JAMES A. FITZPATRICK NUCLEAR POWER PLANT

AMENDMENT TO FACILITY OPERATING LICENSE

Amendment No. 74
License No. DPR-59

ATTACHMENT TO LICENSE AMENDMENT NO. 74

Figure 3.1-2

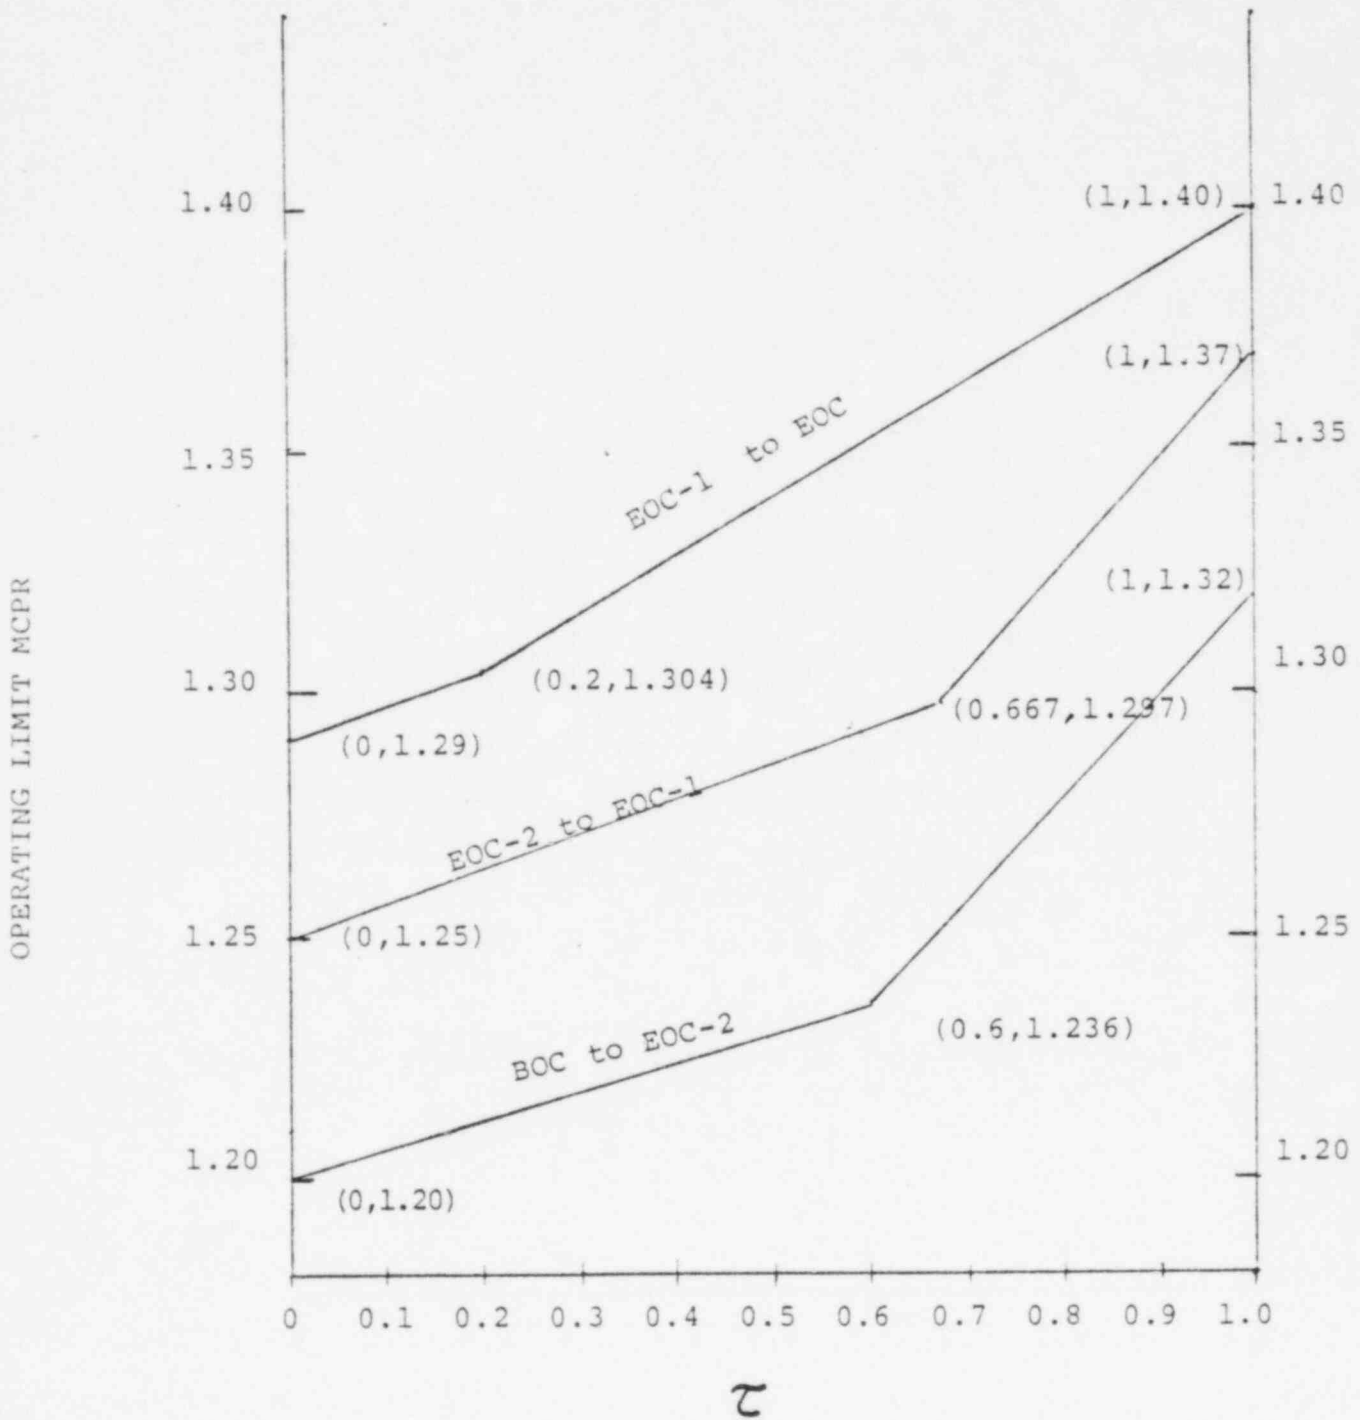
2. If requirement 4.1.E.1 is not met (i.e. $\tau_B < \tau_{AVE}$) then the Operating Limit MPR values (as a function of τ) are as given in Figure 3.1-2.

*Note: Should the operating limit MPR obtained from this figure be less than the operating limit MPR found in Specification 3.1.B.1 for the applicable RWM trip level setting then specification 3.1.B.1 shall apply.

Figure 3.5-10

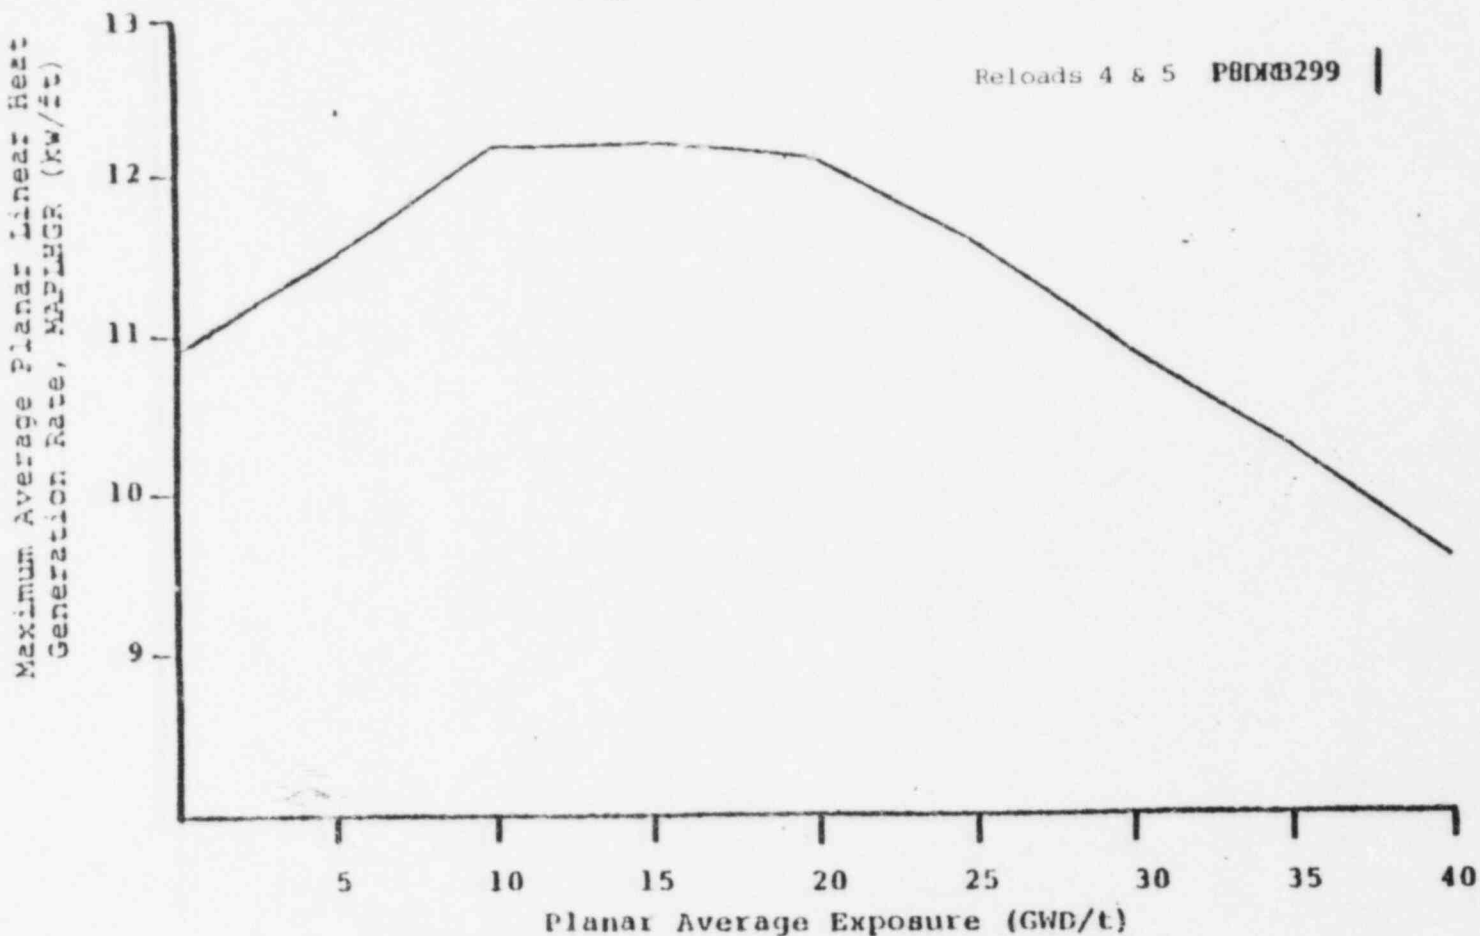
The APIHGR for each type of fuel as a function of average planar exposure shall not exceed the limiting value shown in Figures 3.5-6 through 3.5-10. If anytime during reactor power operation greater than 25% of rated power it is determined that the limiting value for APIHGR is being exceeded, action shall then be initiated within 15 minutes to restore operation to within the prescribed limits. If the APIHGR is not returned to within the prescribed limits within two (2) hours, an orderly reactor power reduction shall be commenced immediately. The reactor power shall be reduced to less than 25% of rated power within the next four hours, or until the APIHGR is returned to within the prescribed limits.

are within the 10 CFR 50 Appendix K limit. The limiting value for APIHGR is shown in Figure 3.5-6 through 3.5-10.
